MINUTES
REGULAR MEETING
DEMAREST ZONING BOARD OF ADJUSTMENT

January 18, 2022

Variance Application #821.21

83 Pine Terrace
 Block 84.04, Lot 9
 Applicant: Robert & Andrea Kessner
 Zone BB

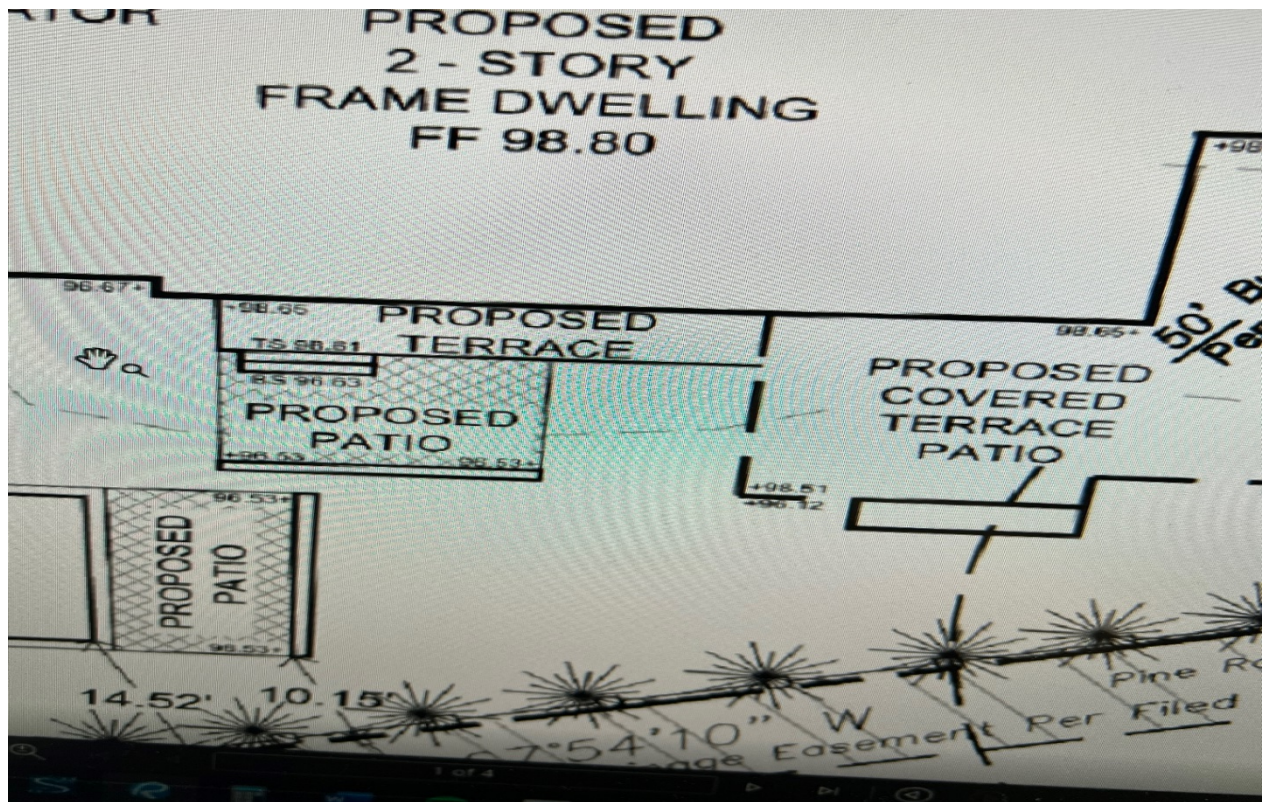
Mr. D'Agostino shared his screen, and showed Exhibit A.201, he showed that front yard setback had been reduced and the proposed elevated rear terrace have been eliminated and shifted it to the left and reduced the width of the covered terrace, this combined reduction has reduced building coverage by 156 sq. ft.

Mr. McLain had a quick question to make sure he was looking at the correct plan. Mr. McLain stated that the revised 12/29/21 plan he has in front of him was different than the one on screen. On the screen, exhibit SI.0, there is a "proposed patio" connecting to a "proposed covered terrace patio" by a "proposed terrace." Mr. McLain stated that his revised 12/29/21 plan has that "proposed terrace" labeled as "proposed raised walk." Mr. McLain said his plans do not match what he is looking at on the screen. Chair Ms. Hayden also said her plan says, "proposed raised walk." Mr. McLain asked if the rest of the plans are the same or not.

Mr. D'Agostino said the only instance that says "proposed raised walkway" that he has is on exhibit A.201. He shows it on screen, and says that is on the architectural plans, and that everyone should have the same plans that he has.
